Re: FASSNIGHT

# TELEVISION INSPECTION

**To:** Lyman, Randy; Dotson, Art; 'pmelgren@ghnae.com'  
**Cc:** Pabst, Gene  
**Subject:** RE: Fassnight Pool Project

P18  
FC08

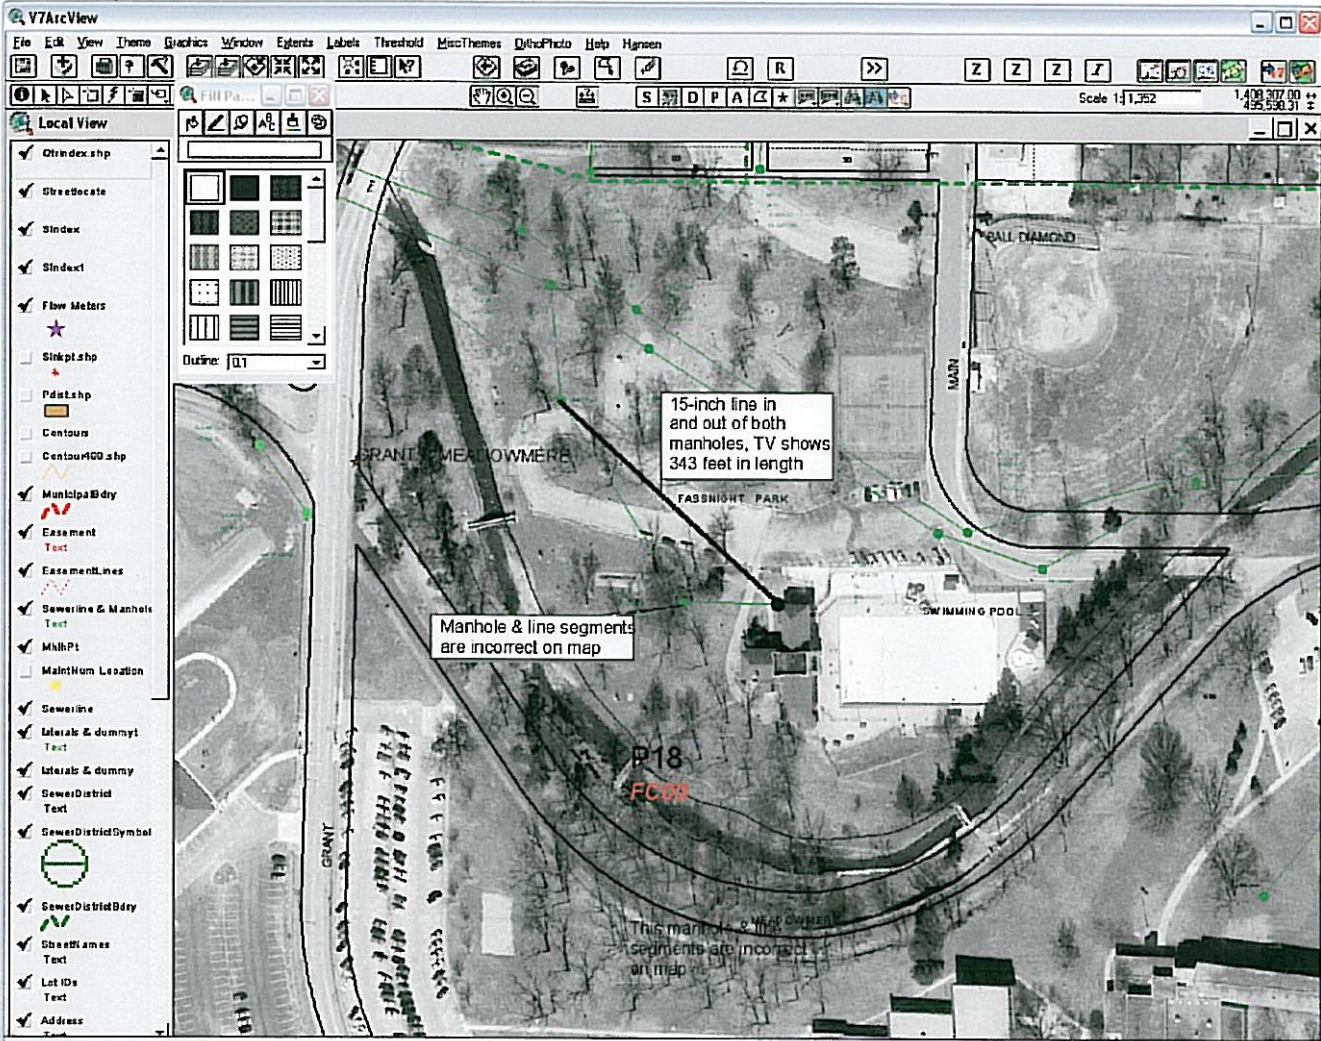
Here is the map with new information after field inspection. The map is wrong as noted on the attached document.

field verify pipe inlets and outlet sizes, invert thru manhole?

P18 NE  
FC09

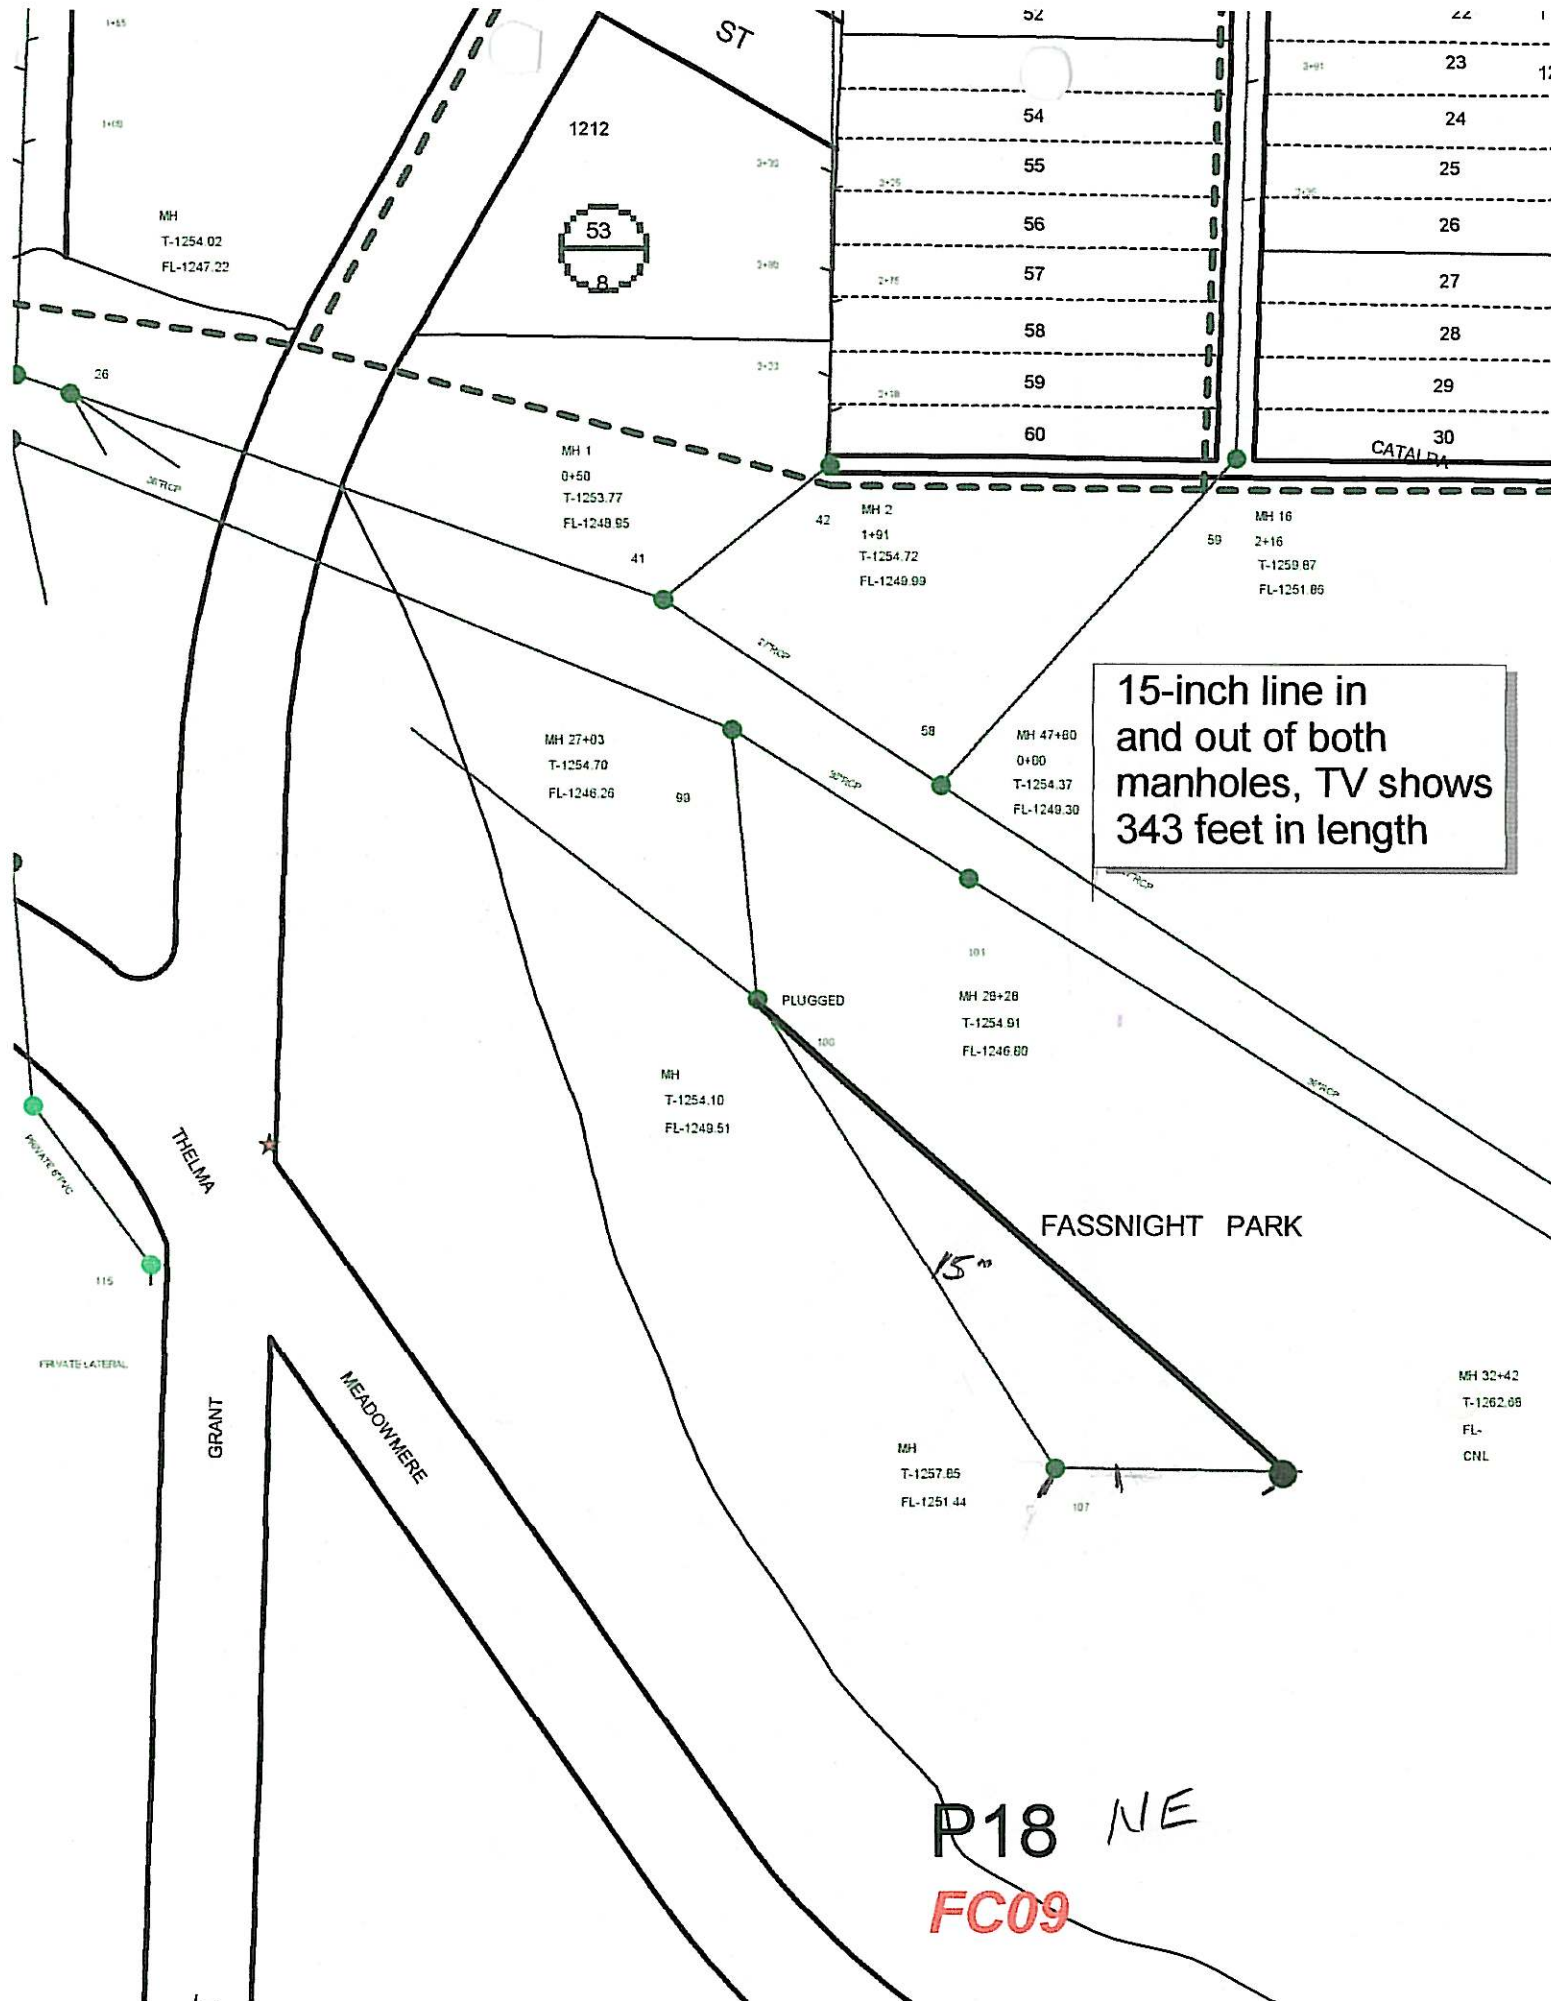
15-inch line in and out of both manholes, TV shows 343 feet in length
